# UNITED STATES PATENT AND TRADEMARK OFFICE

APPLICATION NO.	FILING DATE	FIRST NAMED INVENTOR	ATTORNEY DOCKET NO.	CONFIRMATION NO.
09/471,981	12/23/1999	EMIKO IGAKI	MTS-3181US	8182

# Office Action Summary

## DETAILED ACTION

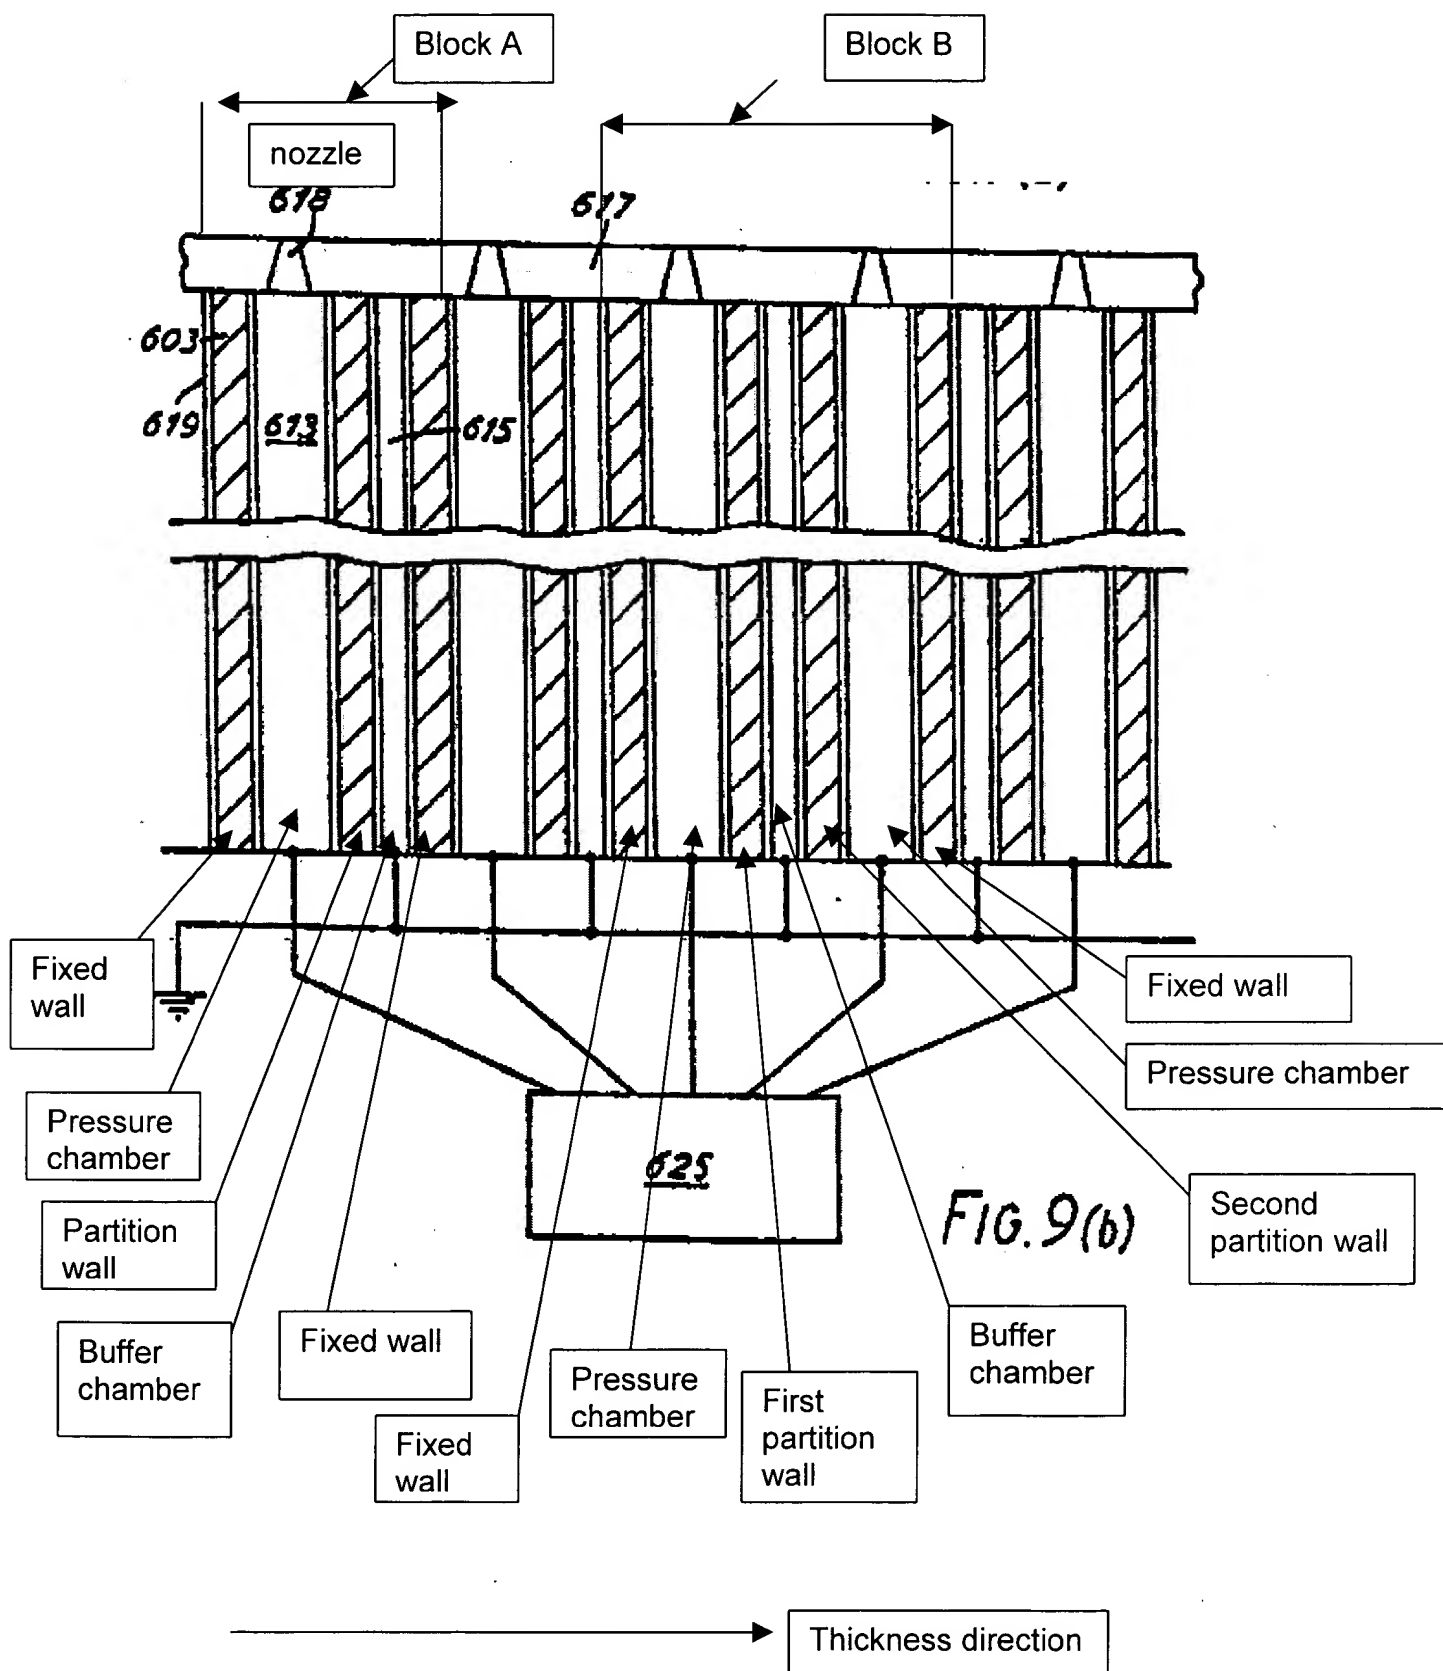
3. Claims 1, 4, 5, 40, 41 and 43 are rejected under 35 U.S.C. 102b as being anticipated by Bartky et al. (USPN 5,003,679).

With respect to claim 1, Bartky et al. discloses an recording head comprising:

- One piezoelectric block having an ink pressure chamber (Fig.9b: element 613) communicating with a nozzle (element 618) for ejecting ink, a partition wall serving as a driving portion that includes a piezoelectric element, a pressure buffer chamber (element 615) and two fixed wall (Fig.9b)
- Ink pressure chamber, partition wall and pressure buffer chamber are respectively arranged in sequence along a thickness direction of piezoelectric block
- One of fixed walls is disposed adjacent to the ink pressure chamber and another fixed wall is disposed adjacent to the pressure buffer chamber (Fig.9b)

- One piezoelectric block (A) as shows in figure 9b, having an ink pressure chamber (A) communicating with a nozzle (A) for eject ink, a partition wall (A) serving as a driving portion that includes a piezoelectric element and at least tow electrodes (A) for driving the piezoelectric (A), a pressure buffer chamber (A) and two fixed walls (A),
- One piezoelectric block (B) as shows in figure 9b, having first and second ink pressure chamber (B) communicating with a nozzle (A) for eject ink, first and second partition wall (B) serving as a driving portion for one of the two ink pressure chamber, each partition wall includes a piezoelectric

element and at least two electrodes (B) for driving the piezoelectric (B), a pressure buffer chamber (B) and first and second fixed walls (B),

- Wherein the piezoelectric block (A) configured such that Ink pressure chamber (A), partition wall (A) and pressure buffer chamber (A) are respectively arranged in sequence along a thickness direction of piezoelectric block,
- One of the fixed walls (A) is disposed adjacent to the ink pressure chamber (A) and another fixed wall is disposed adjacent to the pressure buffer chamber (A),
- Wherein the piezoelectric block (B) configured such that Ink pressure chamber (B), partition wall (B) and pressure buffer chamber (B) are respectively arranged in sequence along a thickness direction of piezoelectric block,
- One of the fixed walls (B) is disposed adjacent to the first ink pressure chamber (B) and another fixed wall is disposed adjacent to the second pressure chamber (B)

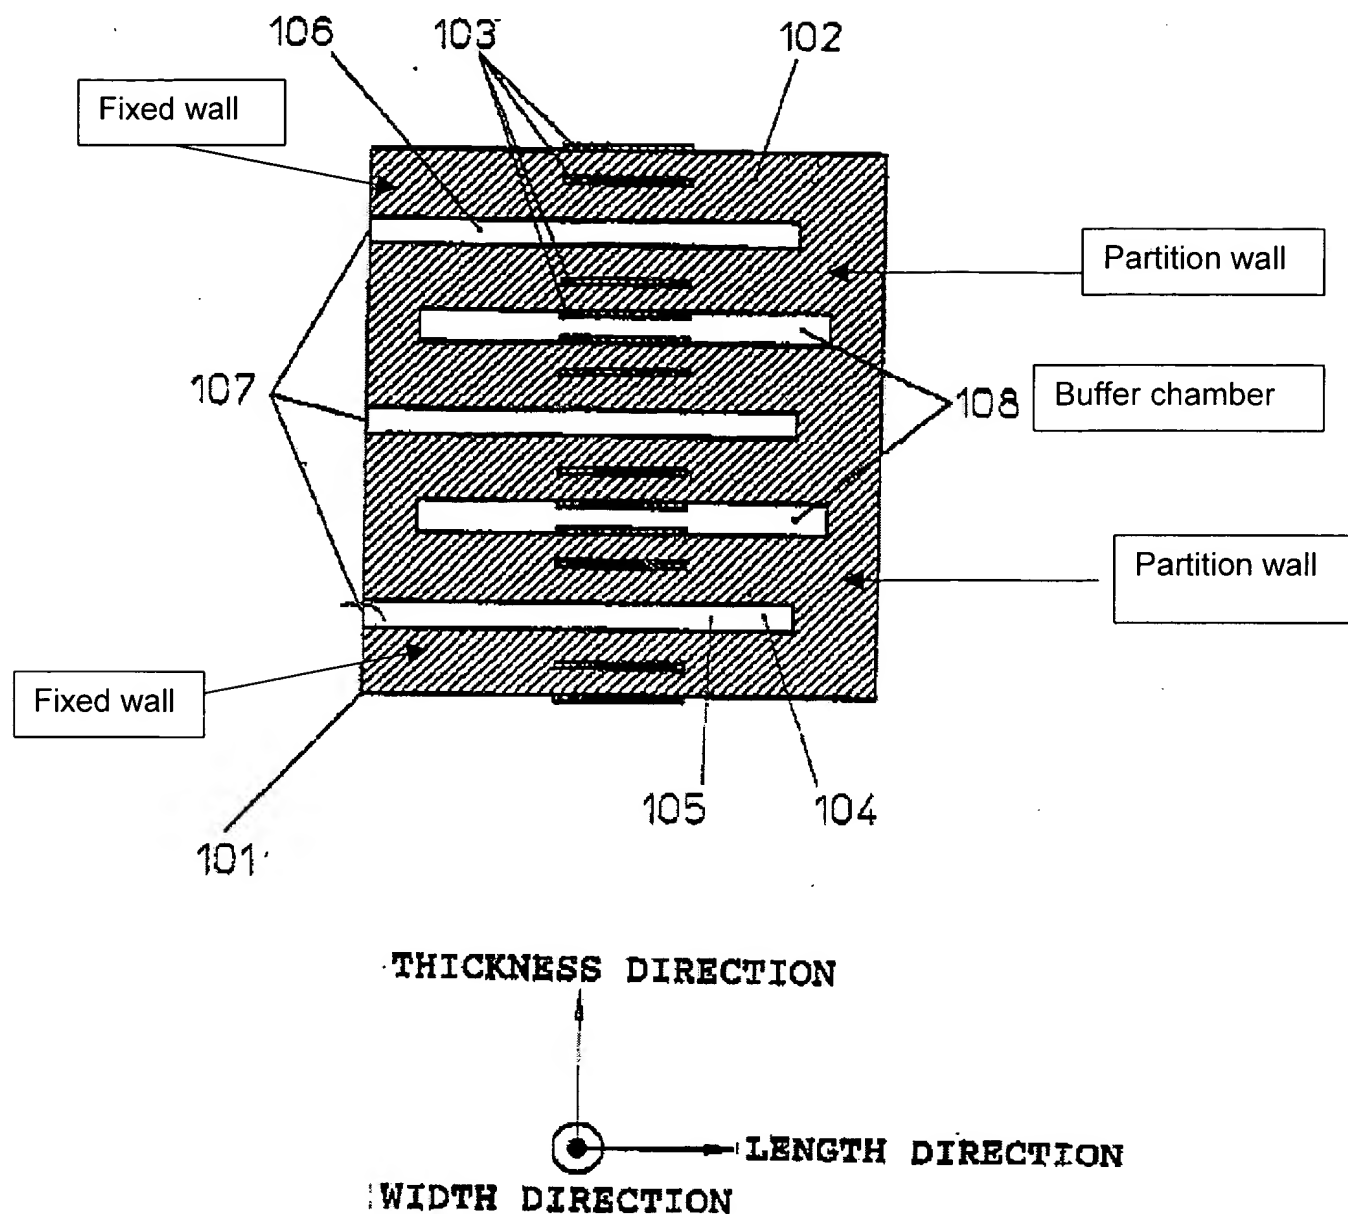
4. Claims 3, 39, 42, 44-50, 58, 61-63, 71, 76 and 81 are rejected under 35 U.S.C. 102(b) as being anticipated by Applicant's Admitted Prior Art (AAPA).

AAPA discloses in figure 17:

- an ink-jet recording head comprising at least one piezoelectric block (B);
- Each piezoelectric block (B) has first and second ink pressure chambers (106);

- each pressure chamber communicating with a nozzle (107) first and second partition walls (Fig.17);
- each partition wall serving as a driving portion for one of the ink pressure chambers, each partition wall including a piezoelectric element and two electrodes ((Fig.17) for driving said piezoelectric element;

- a pressure buffer chamber (108) and first and second fixed walls (Fig.17);
- The first fixed wall, the first ink pressure chamber, the first partition wall, the pressure buffer chamber, the second partition wall, the second ink pressure chamber, and the second fixed wall are arranged in sequence along a thickness direction (Fig.17) and surface of the electrodes are oriented perpendicular to the thickness direction, the driving portion is polarized in the thickness direction and perpendicular to the surfaces of the electrodes (Fig.17), at last one electrodes (103) for controlling, by

bending of the electrode, whether the partition wall bend toward a side of the ink pressure chamber or bends towards a side of the pressure buffer

- at least one of the electrodes is embedded in the wall (103);
- a plurality of these blocks, arranged in the thickness direction.
- the pressure buffer chambers are all closed on a side at which the nozzle communicating with the ink pressure chamber is open (see Fig. 4).
- there are two electrodes per partition wall, one of which is exposed to the pressure buffer and the other exposed to the ink pressure chamber;
- a portion at which the electrodes on a partition wall face each other is included in a portion at which the ink pressure chamber and pressure buffer chamber face each other (Fig.17);
- the piezoelectric block is an integrally sintered one piece block structure;
- the distance between nozzles appears to be constant (Fig.17).
